# LINCOLN PROFESSIONAL PARK FILING NO. 1 LOT 1 MAVERIK INC. STORE SITE PLAN

No.	Date	Description
1	5-24-22	CITY REVIEW
2	7-13-22	CITY REVIEW

**MAVERIK INC. STORE**  
**LINCOLN AVE. AND DRANSFELDT RD.**  
**PARKER, CO**  
**SITE PLAN**

### 1 SITE PHOTOMETRIC PLAN

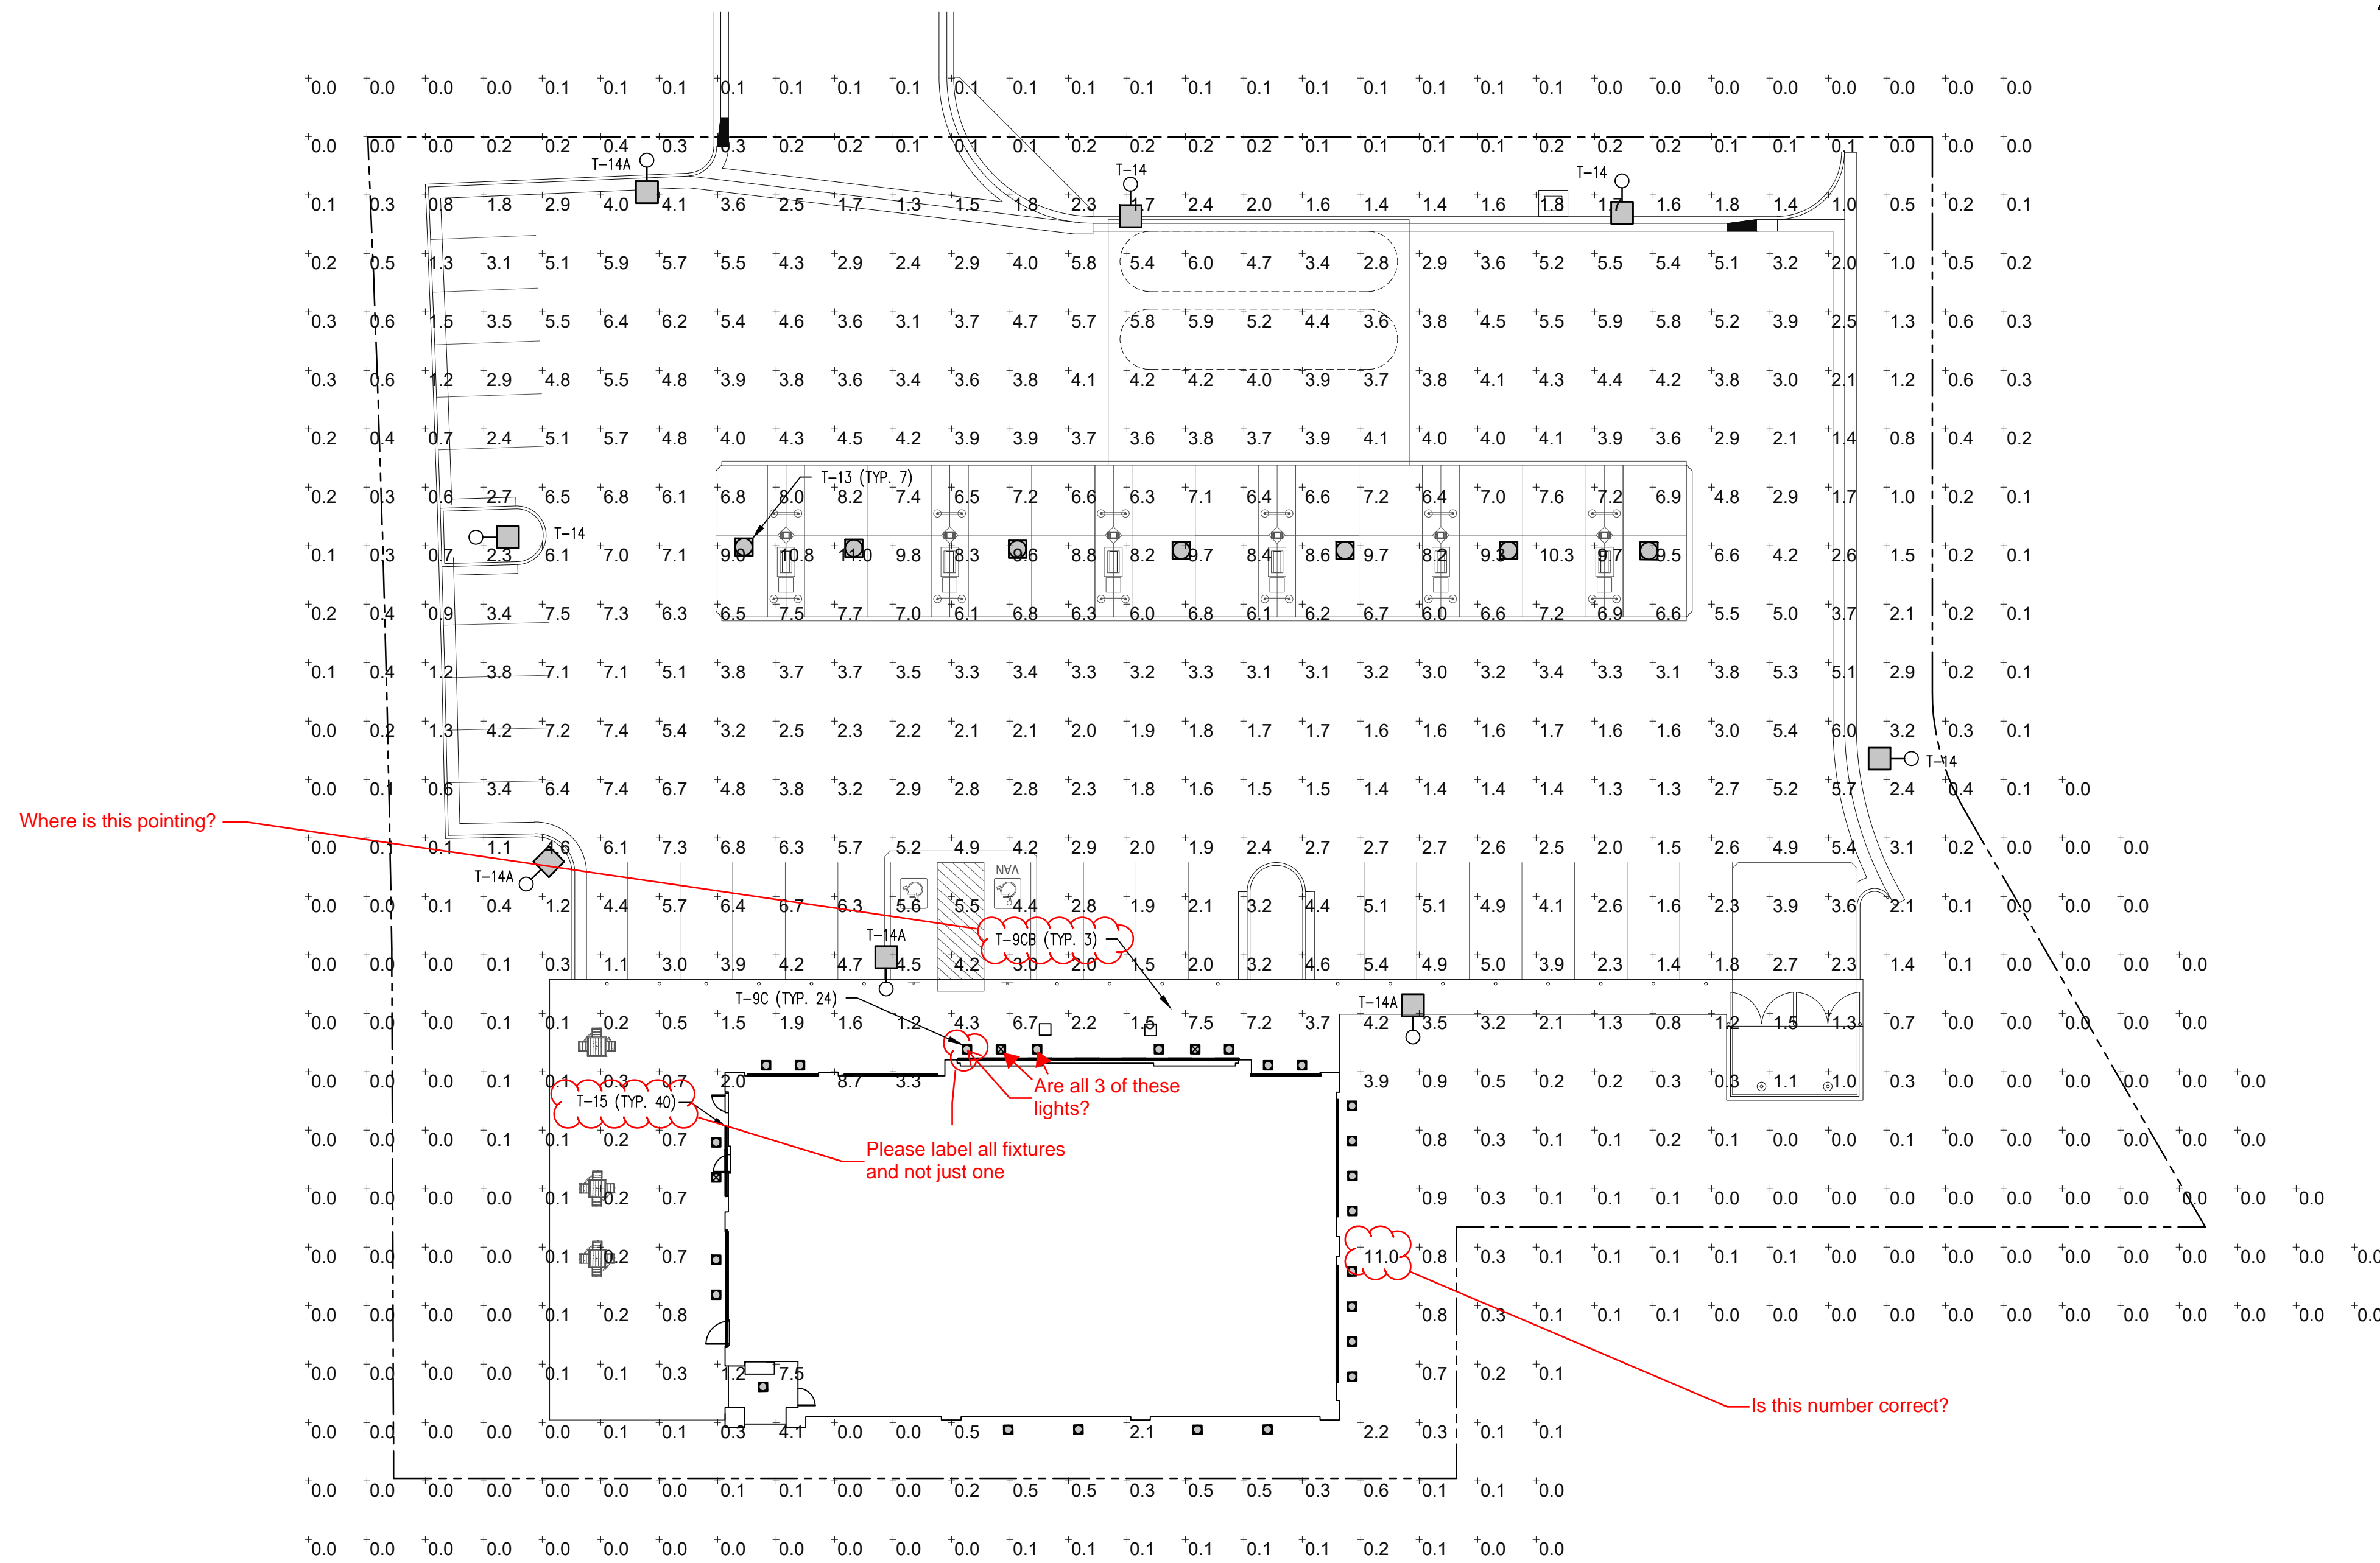
Does the white color change the look of the

Where is this pointing?

Are all 3 of these lights?  
Please label all fixtures and not just one

Is this number correct?

The T-15 luminaire housing is white and fully recessed in the cove making it essentially invisible. It will not change the look of the exterior.
